New XT Series Fuel Tank

Figure 2. New Tank 14 065 63-S.

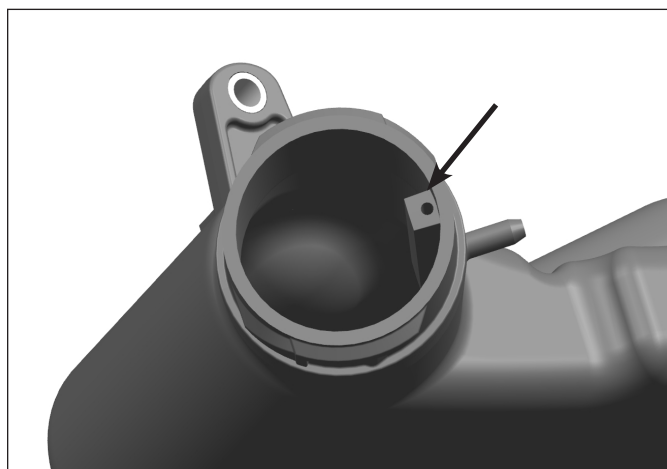
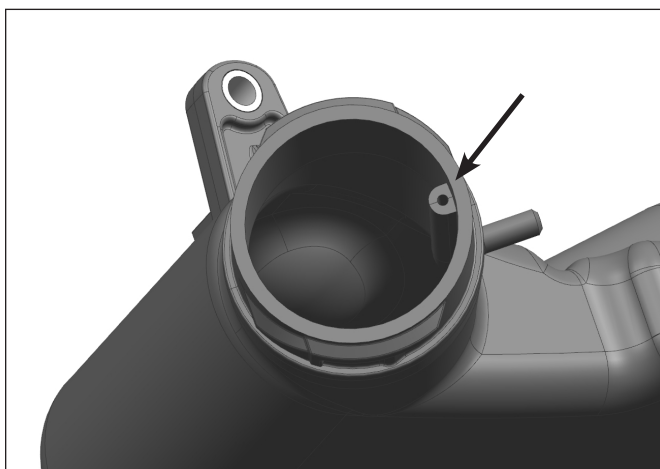
A new 14 065 63-S fuel tank has been implemented with a material that addresses isolated incidents of nylon leaching into the fuel system (previously covered in the 2013-2014 Service Update Book), as well as poor fuel cap installation and fit.

This new tank should be used as the replacement for any such reports and can be identified visually by the round shape of the internal tank neck feature shown below.

If you have inventory of the 14 065 56-S fuel tank, please contact your Central Distributor for a new replacement.
